# UNITED STATES PATENT AND TRADEMARK OFFICE

APPLICATION NO.	FILING DATE	FIRST NAMED INVENTOR	ATTORNEY DOCKET NO.	CONFIRMATION NO.
10/807,040	03/23/2004	Takashi Akita	04995/140001	2727

**Office Action Summary**

**DETAILED ACTION**

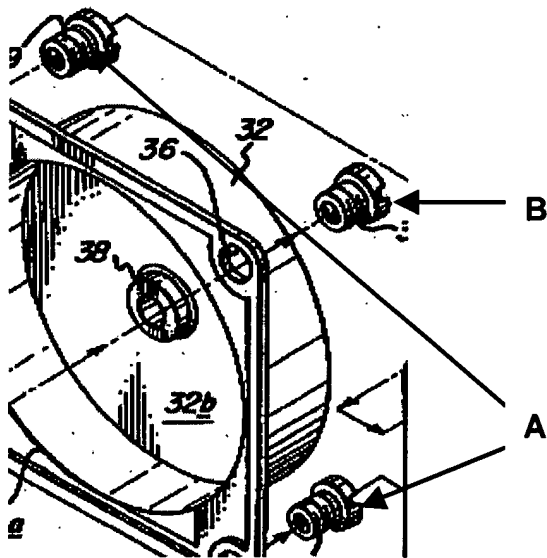
As to claim 1, Low discloses an attachment structure of a rear panel to a tuner, in which a rear panel **20** is attached and fixed onto a front surface of a tuner **30**, the tuner having two connector connection parts **A** (Figure 1 reprinted below with annotations) protruding in front and a small protrusion **B** with a tapped hole for panel attachment disposed on an imaginary (curved) line between the connector connection parts, the attachment structure comprising:

the rear panel having two holes **26** for inserting the connector connection parts in portions corresponding to the two connector connection parts of the tuner and a small cylindrical part **23** that is formed protrusively to the tuner side in a portion corresponding to the small protrusion with the tapped hole of the tuner; and

wherein the two connector connection parts of the tuner are inserted into the two holes of the rear panel, and a leading end of the small cylindrical part is brought into contact with a front surface of the small protrusion with the tapped hole of the tuner, and

under this state, the male screw is inserted into the small cylindrical part from the front surface side of the rear panel and further a leading end of the male screw is screwed into the tapped hole of the small protrusion with the tapped hole of the tuner, whereby the rear panel is attached and fixed onto the front surface of the tuner (Figures 1 and 2B).

Examiner disagrees. As to claims 1 and 2, Low discloses an attachment structure wherein the tuner has two connector connection parts **A** protruding in front and a small protrusion **B** with a tapped hole for panel attachment disposed on an imaginary (curved) line between the connector connection parts.
